Re: Burger King
7101 Lomas Blvd. NE
Traffic Circulation Layout
Architect's Stamp 01-31-23 (J19-D052)

The TCL submittal received 07-21-2023 is approved for Building Permit by Transportation. A copy of the stamped and signed plan will be needed for each of the building permit plans. Please keep the original to be used for certification of the site for final C.O. for Transportation.

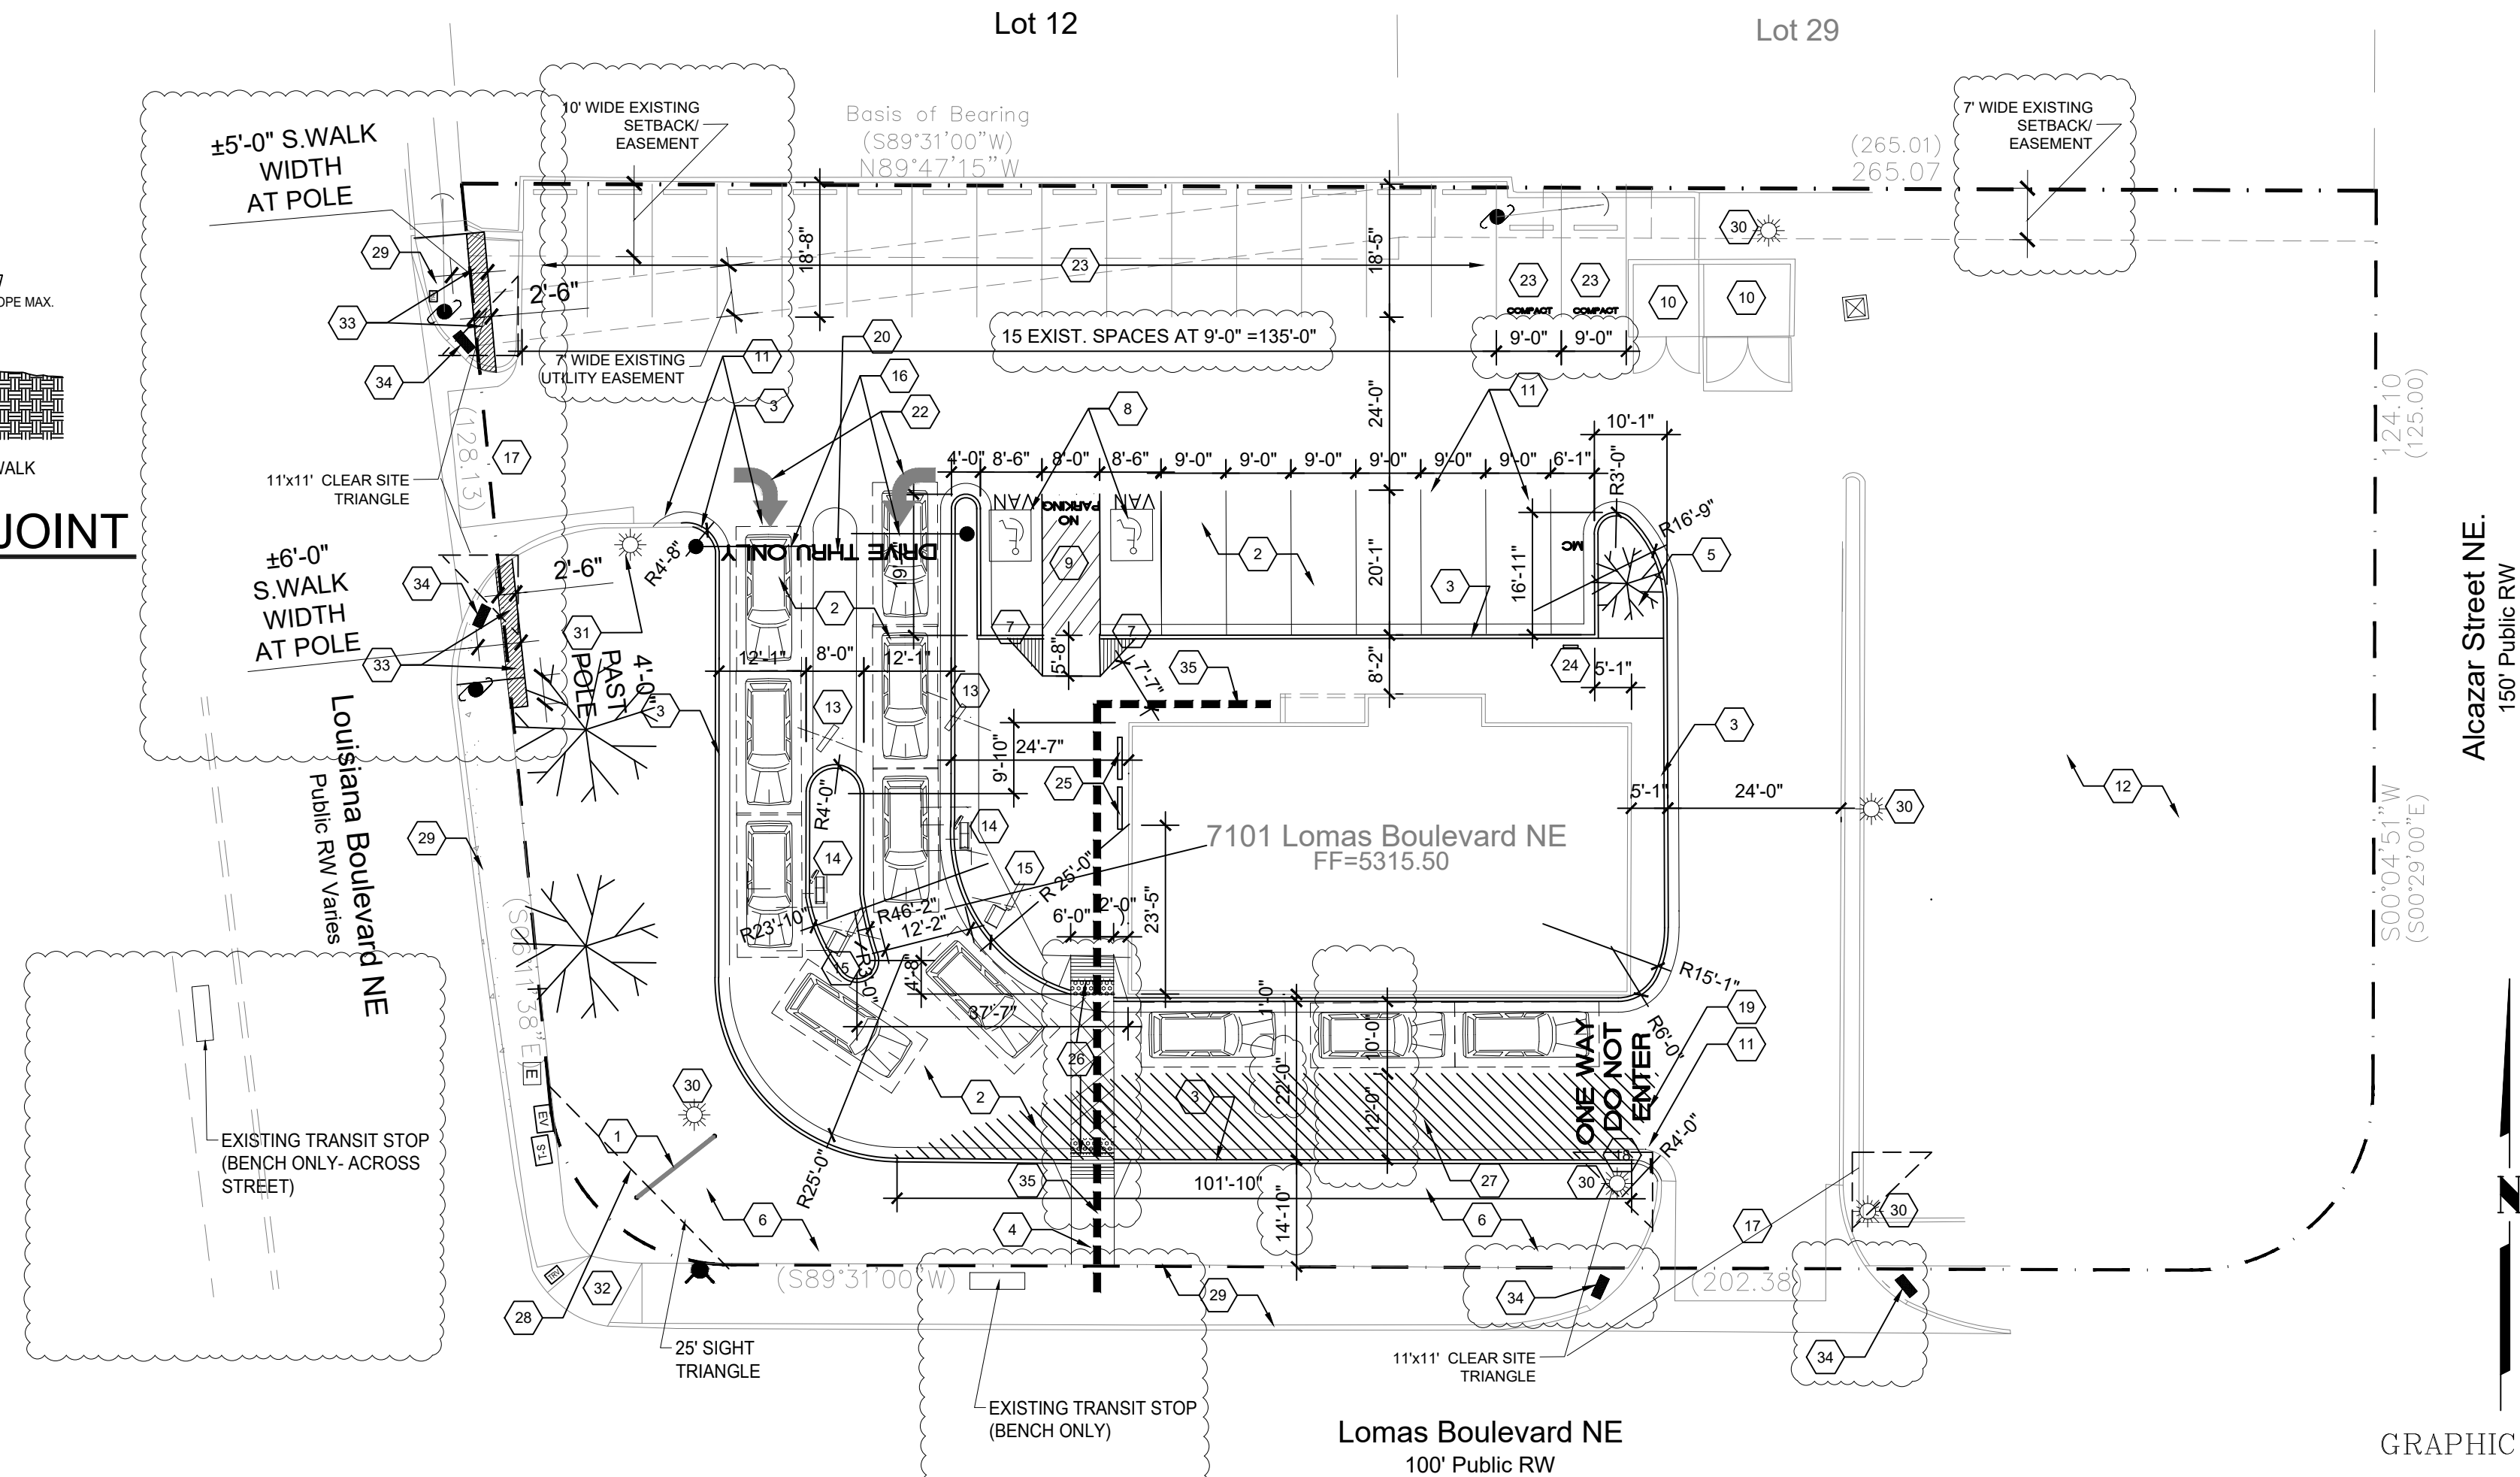
keynote 33: Sidewalk Easement is a Condition of Releasing
Final CO.

32. EXISTING PEDESTRIAN RAMP.
33. CONSTRUCT A 2'-6" WIDE SIDEWALK CONC
STRIP TO WIDEN SIDEWALK AROUND
EXISTING TELEPHONE POLE AT THIS
LOCATION SUCH THAT 4'-0" IS CLEAR MIN.
BETWEEN POLE AND INNER EDGE OF
WALK- BOTH SIDES OF ACCESS ENTRY.
FOLLOW CONTOURS OF WALK AND RAMP
FLUSH WITH ADJACENT AND EXTEND TO
CURB LINE.
